Monticello Nuclear Generating Plant
2807 W County Road 75
Monticello, MN 55362

Monticello Nuclear Generating Plant
Docket No. 50-263
Renewed Facility Operating License No. DPR-22

Responses to Requests for Additional Information Regarding Monticello Nuclear Generating Plant's Overall Integrated Plan Submitted in Response to March 12, 2012 Commission Order Modifying Licenses with Regard to Requirements for Reliable Spent Fuel Pool Instrumentation (Order Number EA-12-051) (TAC No. MF0924)

**Responses to Requests for Additional Information Regarding
Reliable Spent Fuel Pool Instrumentation
(Order EA-12-051)**

Figure – Simplified Elevation Sketch (Not to Scale)

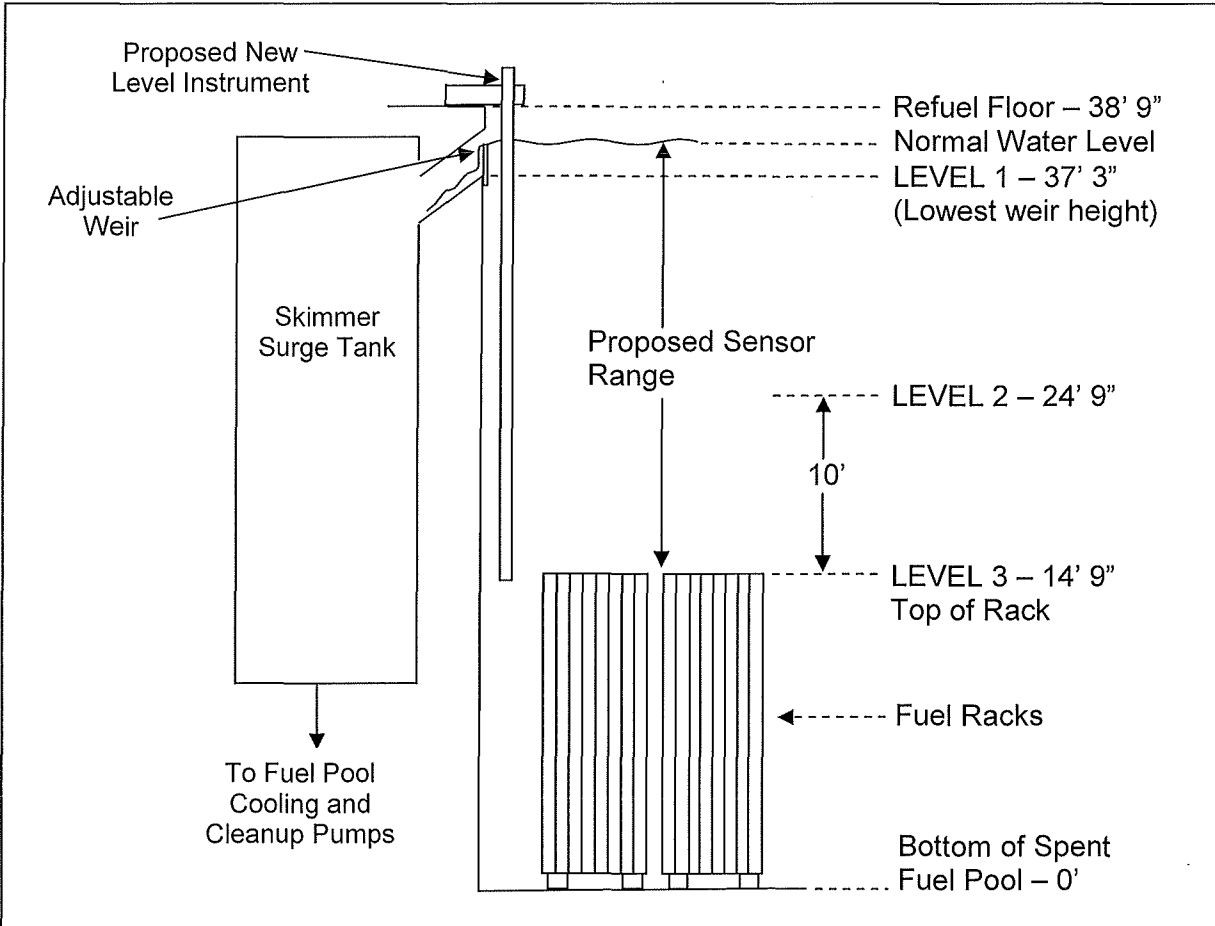
- a) For Level 1, specify how the identified location represents the HIGHER of the two points described in the NEI 12-02 guidance for this level.*
- b) A clearly labeled sketch depicting the elevation view of the proposed typical mounting arrangement for the portions of instrument channel consisting of permanent measurement channel equipment (e.g., fixed level sensors and/or stilling wells, and mounting brackets). Indicate on this sketch the datum values representing Level 1, Level 2, and Level 3 as well as the top of the fuel. Indicate on this sketch the portion of the level sensor measurement range that is sensitive to measurement of the fuel pool level, with respect to the Level 1, Level 2, and Level 3 datum points.*

- b) The sketch on the next page provides an elevation view of the Monticello SFP showing the proposed Level 1, 2, and 3 values, the top of the fuel racks and the bottom of the SFP. The sketch also depicts the proposed mounting arrangement and level sensor range. NSPM's current plan is to begin the design phase for the Spent Fuel Pool Instrumentation (SFPI) system by January 2014. It is anticipated that the final mounting arrangement will be available upon design completion in July 2014. Final mounting arrangement will be provided with the August 2014 six-month status report as part of response to RAI 3.
